SUBJECT: Forwards draft safety evaluation of SEP Topics VI-2, D, "Mass & Energy Release for Possible Pipe Break Inside Containment," & VI-3, "Containment Pressure & Heat Removal Capability" & LLL draft technical evaluation.

SUBJECT: SYSTEMATIC EVALUATION PROGRAM (SEP) FOR THE R. G. GINNA
NUCLEAR POWER PLANT - EVALUATION REPORT ON TOPICS VI-2.D
AND VI-3

SAFETY EVALUATION REPORT
ON
CONTAINMENT PRESSURE AND
HEAT REMOVAL CAPABILITY
SEP TOPIC VI-3
AND
MASS AND ENERGY RELEASE
FOR POSSIBLE PIPE BREAK
INSIDE CONTAINMENT,
SEP TOPIC VI-2.0
FOR THE
R. E. GINNA NUCLEAR POWER PLANT

Figure 1. Containment Atmosphere Pressure, Ginna Double-Ended Suction Leg Break

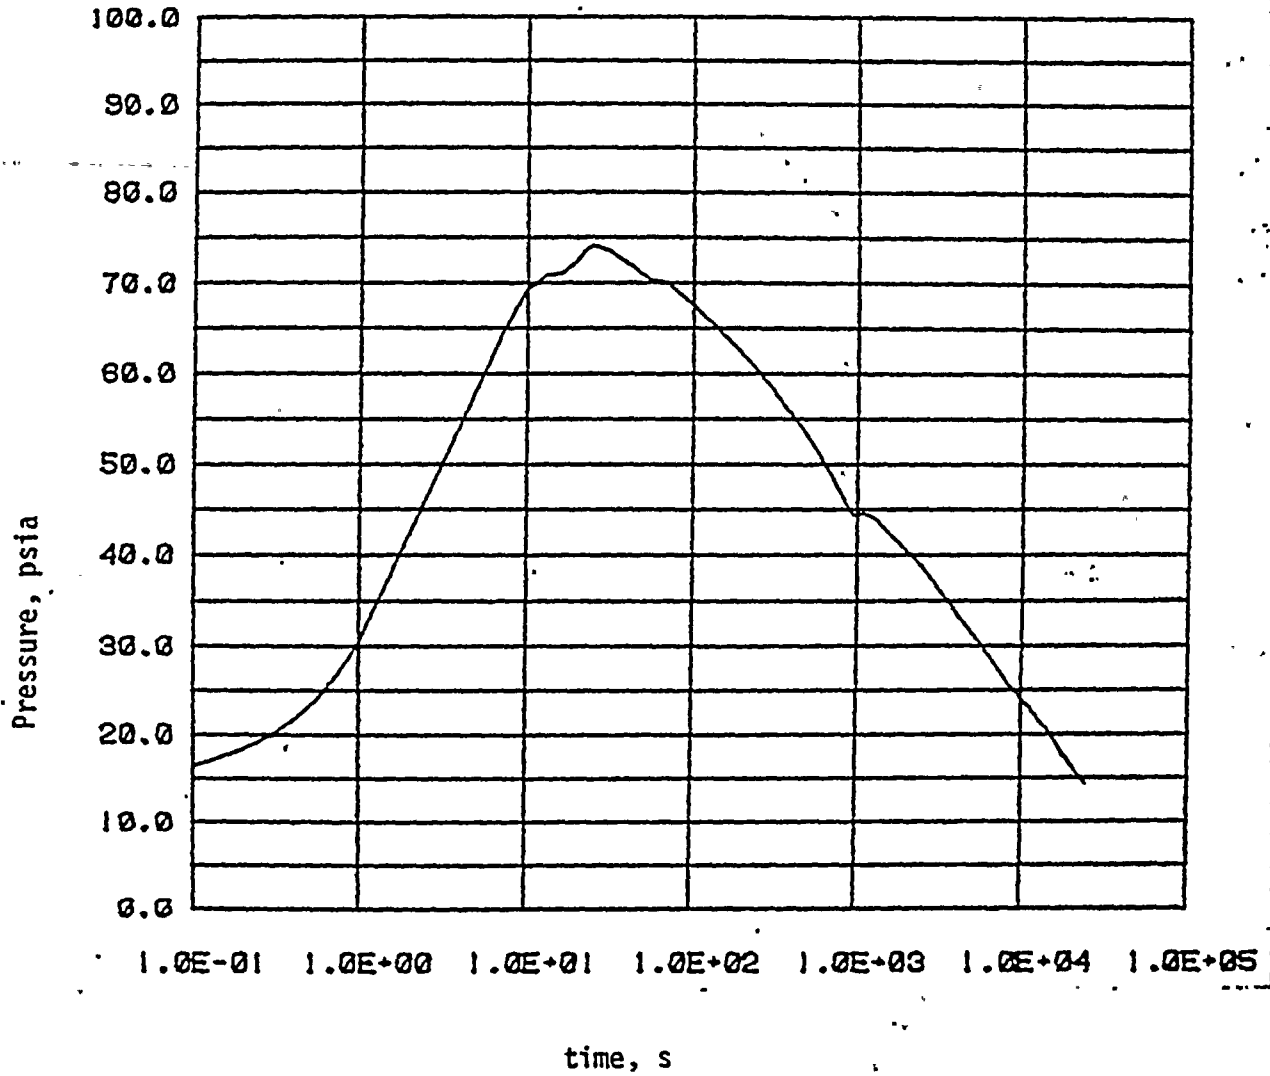
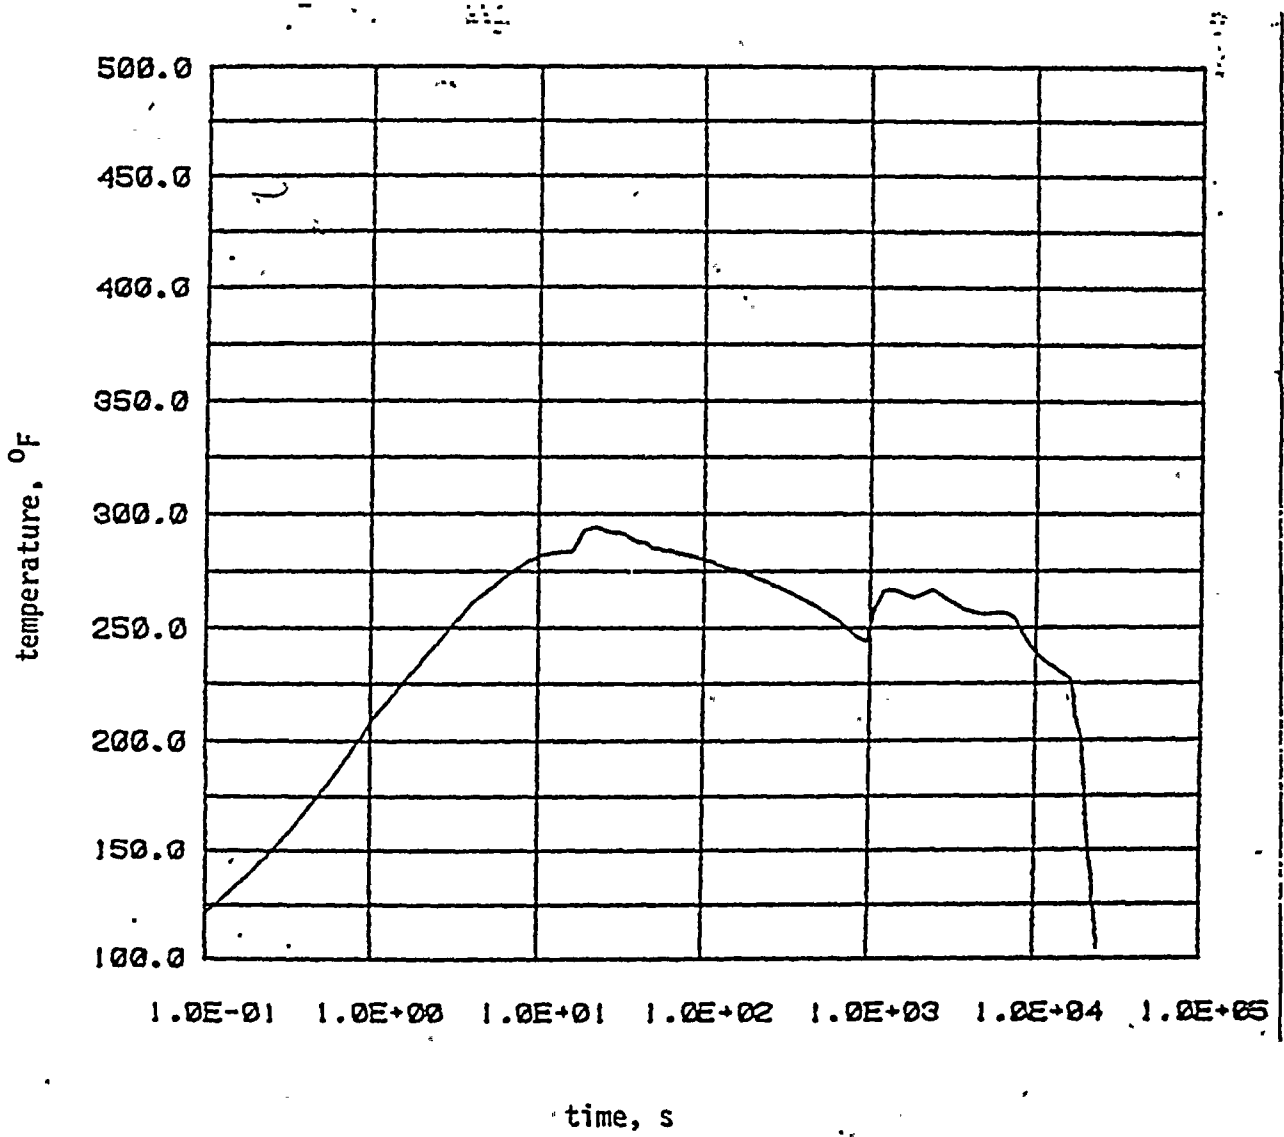
reflood and post-reflood energy were released as superheated steam at the temperature of the secondary side (approximately 500^oF). The results are shown in Figures 1 and 2. The calculated transient reflects a post-accident containment pressure of 74 psia and a temperature of 282^oF. The containment design pressure and temperature are 74 psia and 286^oF, respectively. There is, therefore, a slight margin between the peak calculated pressure and temperature and the design values.

Figure 10. GINNA MSLB, Case 3 - 102% Power with Containment Spray Failure.

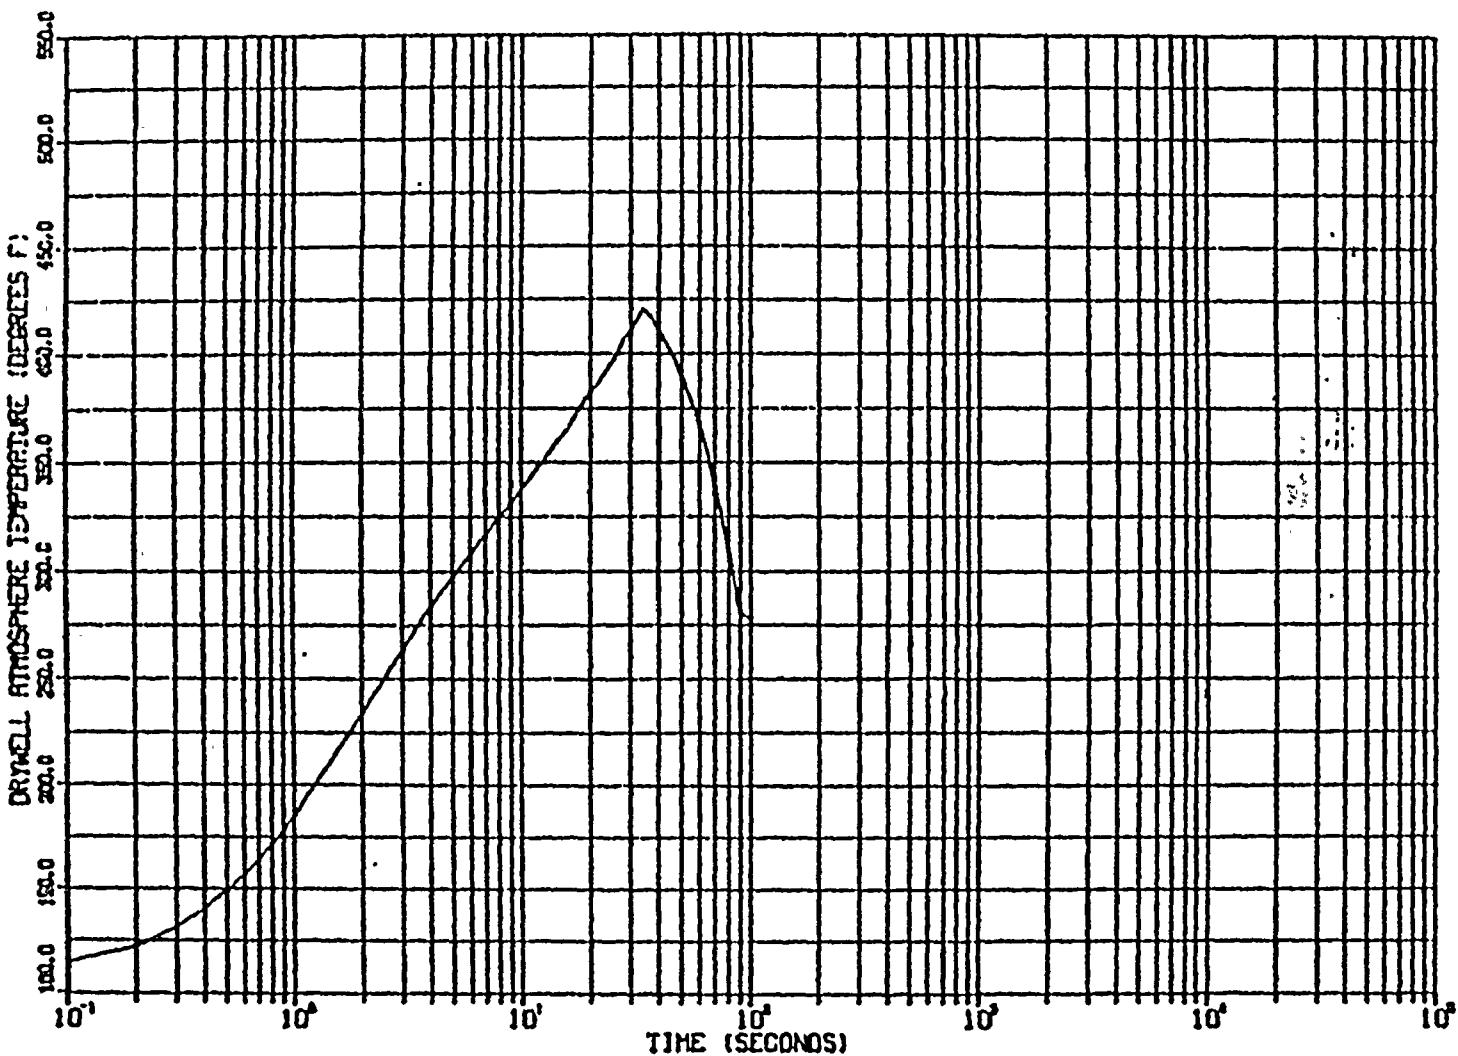
The results of LLNL analyses are extremely conservative, especially for equipment qualification purposes. However, if the licensee chooses to use the results of this report then the MSLB temperature profile in Figure 10 of Appendix A and the LOCA temperature profile in Figure 2 of Appendix A may be used to assess the environmental qualification of Class IE safety-related electrical equipment (USI A-24). Alternatively, the licensee may choose to perform a more realistic analysis to establish environmental conditions for postulated LOCA and steam line breaks.

Figure 13. Ginna MSLB, Case 5 - Hot Standby with Containment Spray Failure

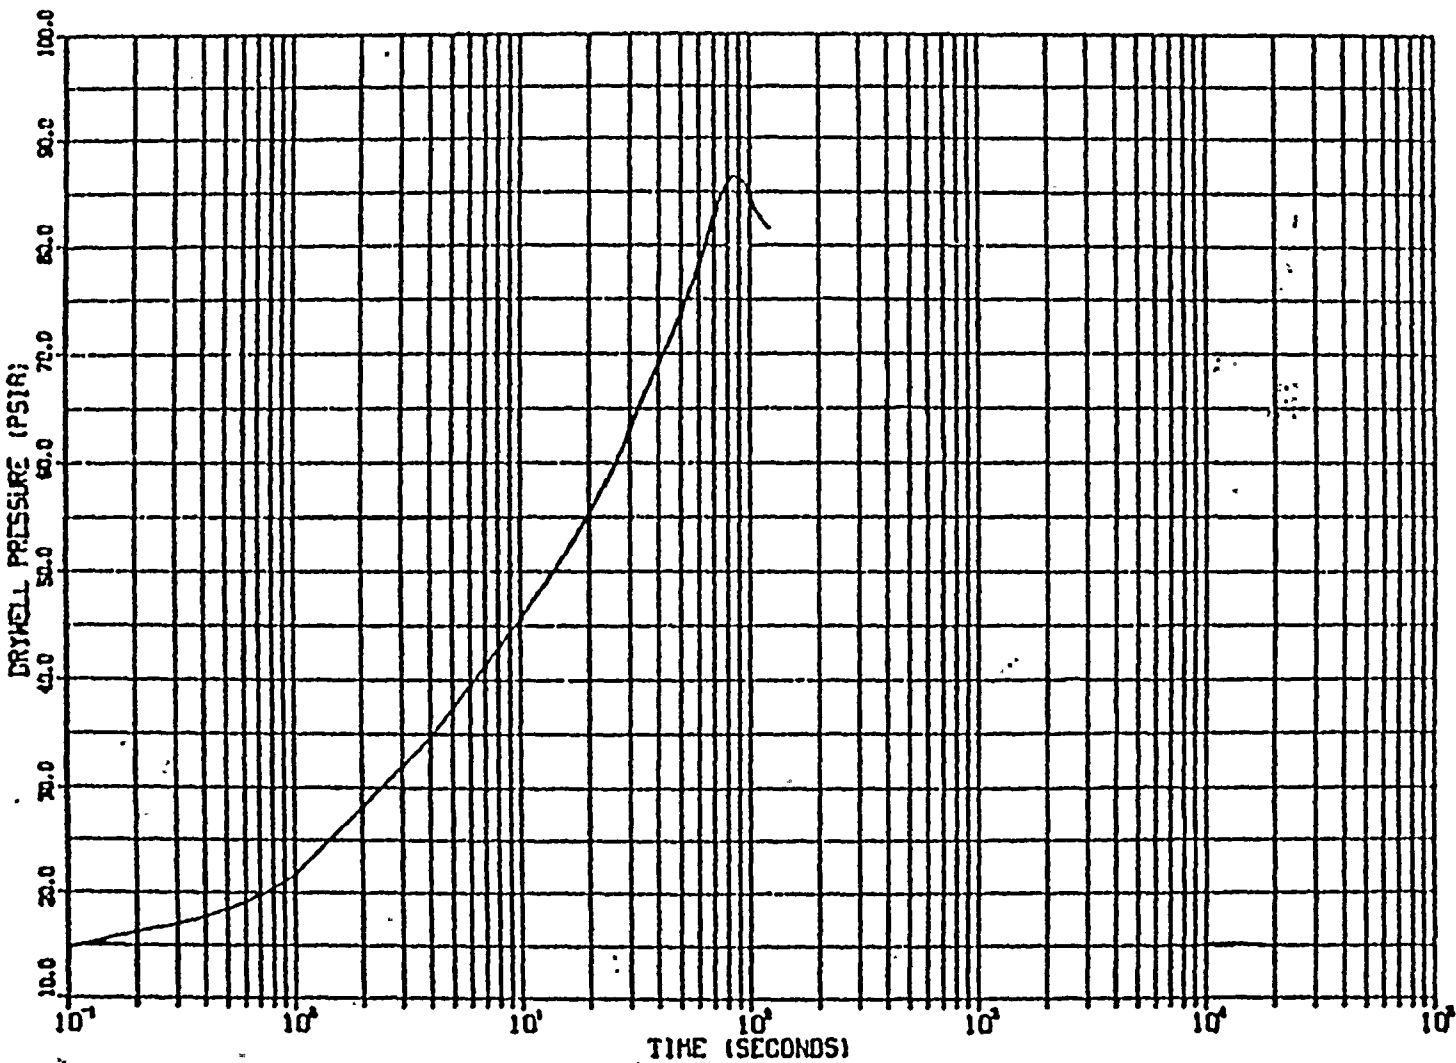
Figures 5 - 14. As shown by Figures 13 and 14, case 5 results in the highest containment pressure, 85.8 psia at 91 seconds after steam-line break, with a containment temperature of 413°F at 34 seconds after steam-line break. Case 5 represents a hot standby plant configuration failure of one containment spray pump. As shown by Figure 10, case 3 results in the highest containment temperature, 421°F at 34 seconds after steam line break, with a corresponding containment peak pressure of 75 psia at 60 seconds after steam line break. Case 3 represents a 102% of full power plant configuration with failure of one containment spray pump.

The containment design conditions are 74.7 psia and 286°F; thus, both values are exceeded as a result of a main steam-line break.
